## LEA UNIT #4H

### Notice of Intent – Sundry

#### Prepare Well to Drill Horizontal Lateral out of Existing Wellbore

**Lea Unit #4  
30-025-02424  
Legacy Reserves  
May 20, 2011  
Conditions of Approval**

### Current Wellbore Condition

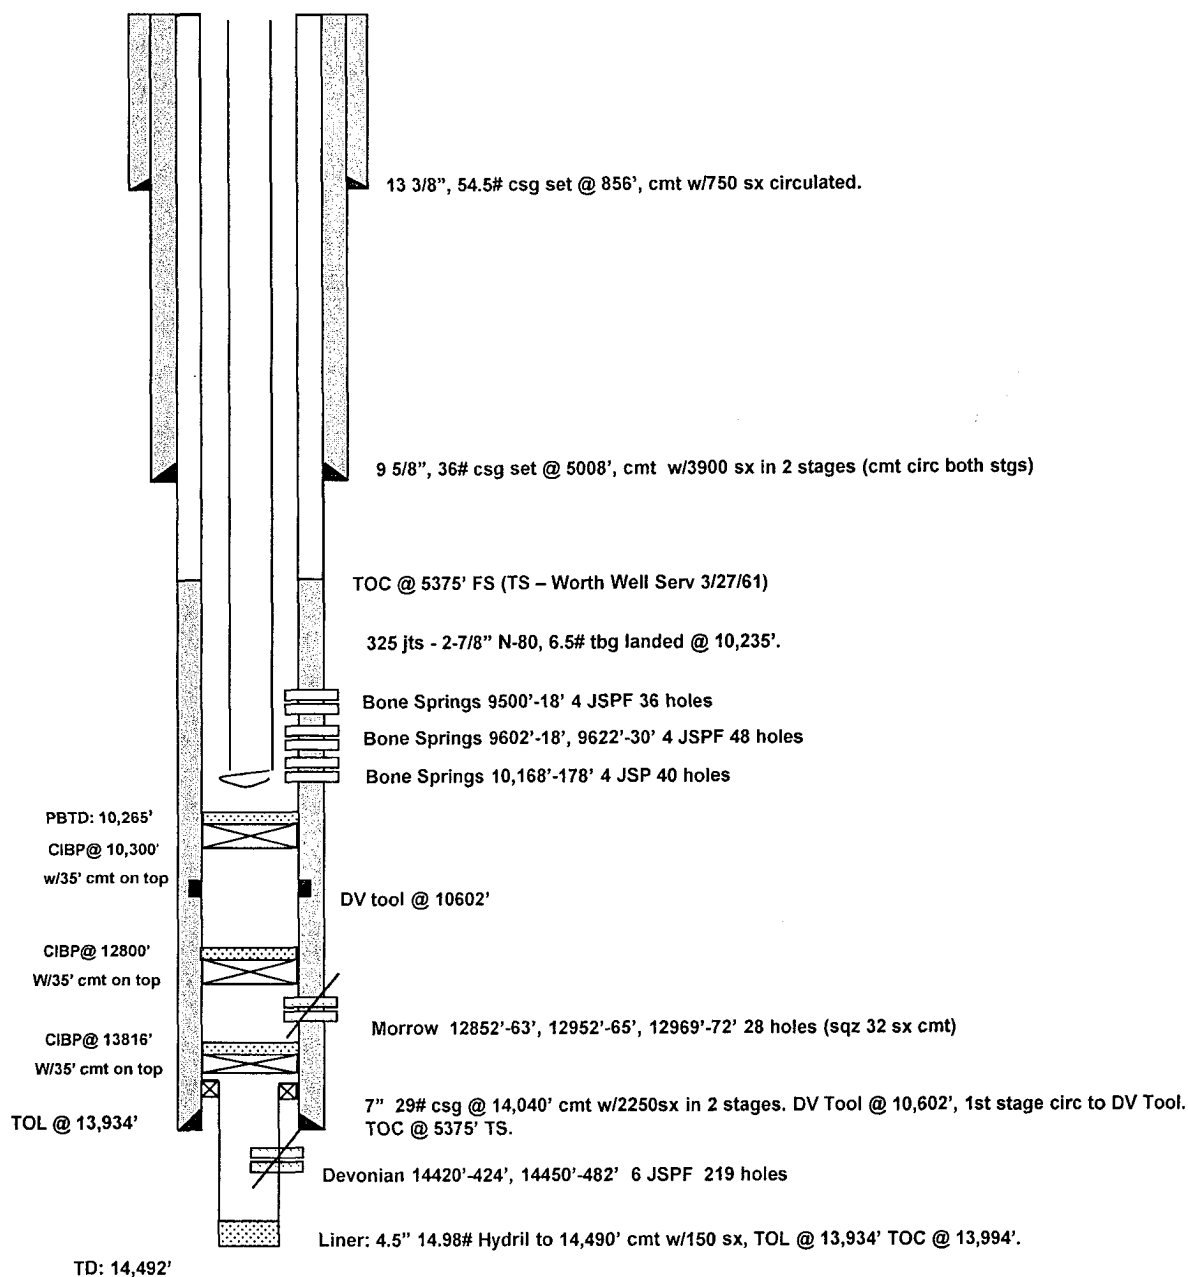
1. MIRU PU to start workover to prepare well to cut window in casing to drill horizontal lateral out of existing wellbore. Install 5k BOP.
2. Set CR & cement squeeze Bone Spring perms 10,168'-178'.
3. Set CR & cement squeeze Bone Spring perms 9,602'-9,630'.
4. Set CR & cement squeeze Bone Spring perms 9,500'-9,518'.
5. Perf 7" csg @ 5,300' (TOC @ ~5,375'). Attempt to break circ.
6. Pump & attempt to circ cement to surf between 7" csg & 9-5/8" csg.
7. Drillout & test squeeze holes across all intervals mentioned in steps 2 – 6.
8. Con't RIH w/bit & DC's & drillout CIBP w/cmt on top @ 10,265'.
9. Con't RIH w/bit & DC's to 10,750'. CHC.
10. Well should be ready to set whipstock and cut window in 7" csg @ ±10,670' MD.

- 1. Surface disturbance beyond the existing pad must have prior approval.**
- 2. Closed loop system required.**
- 3. 5000 (5M) BOP to be used. All blowout preventer (BOP) and related equipment (BOPE) shall comply with reasonable well control requirements. A two ram system with a blind ram and a pipe ram designed for the size of the work string shall be adequate. Tapered work strings will require an additional pipe ram. The manifold shall comply with Onshore Oil and Gas Order #2 Attachment I (5M Diagrams of Choke Manifold Equipment). The accumulator system shall have an immediately available power source to close the rams and retain 200 psi above pre-charge. The pre-charge test shall follow requirements in Onshore Order #2.**

- 4. Operator to have H2S monitoring equipment on location as H2S has been reported from wells in the area.**
- 5. On step 5, if unable to break circ. And unable to circ cmt to surface contact BLM.**

- 6. Report results of testing squeeze hole across all intervals mention in operators steps 2 to 6.**
- 7. Cement Bond Log to be run 9,000 to surface. Submit CBL to BLM for review**

### Proposed Wellbore Configuration

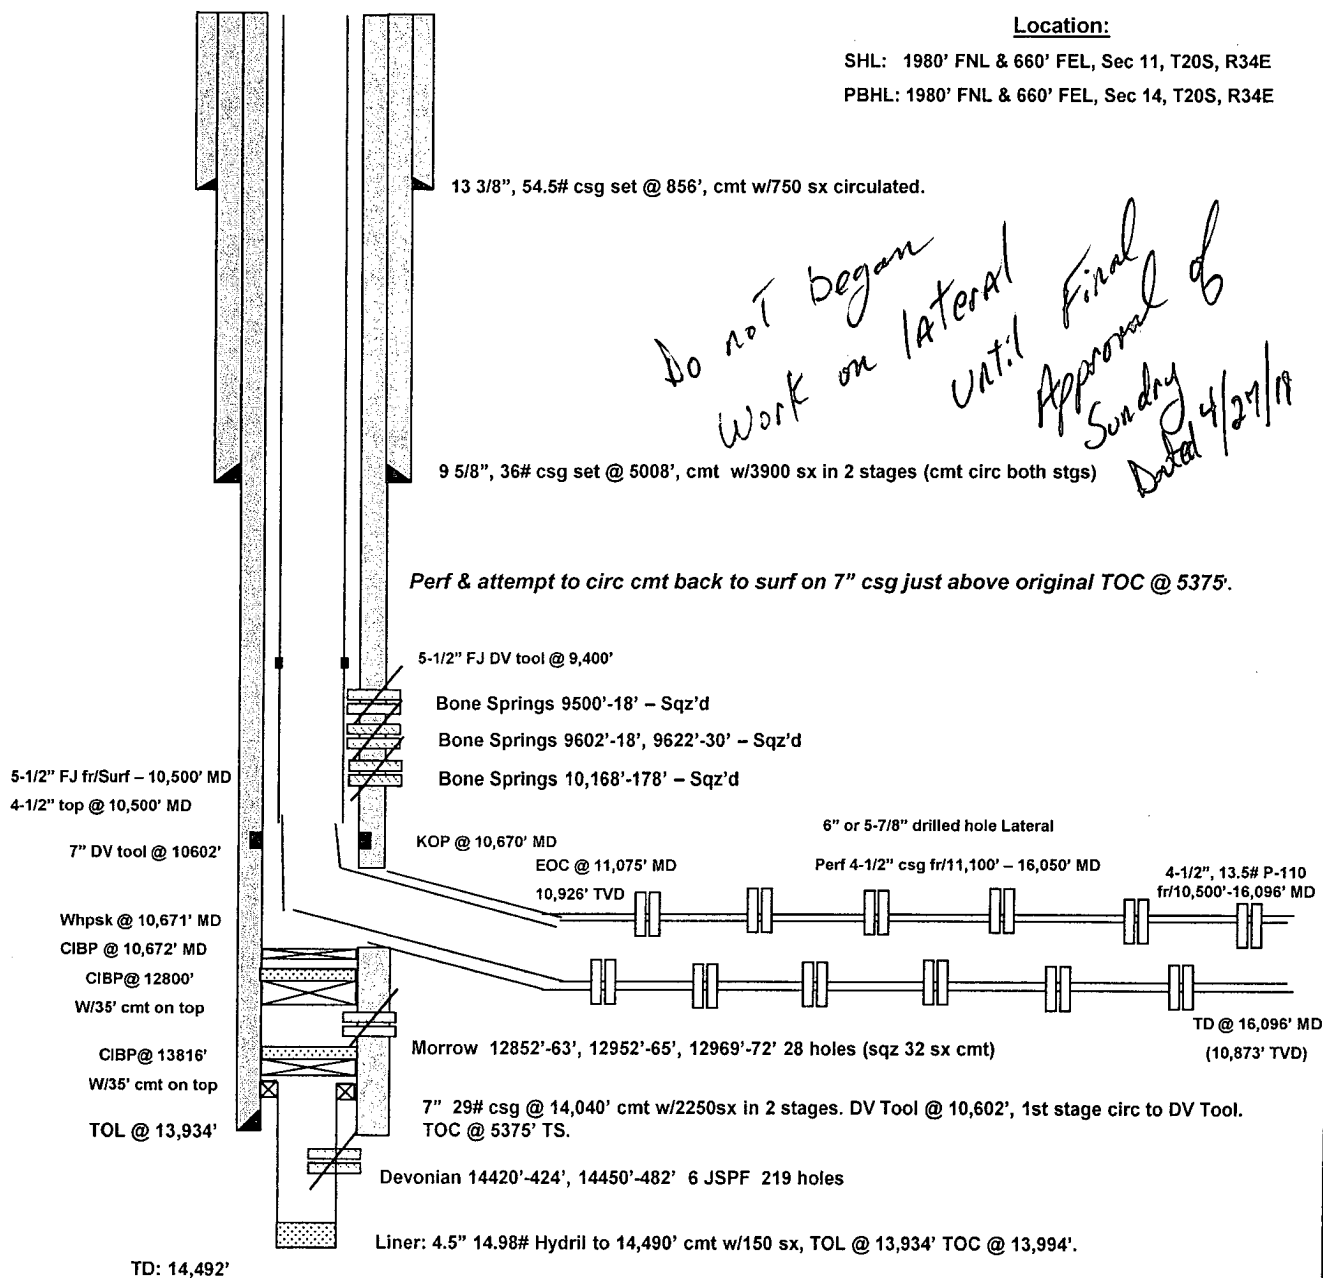
*Do not begin  
Work on lateral  
until Final  
Approval of  
Sundry  
Data 4/27/11*

- 8. Notify BLM when ready to move in Rotary Drilling rig for Horizontal Lateral.**
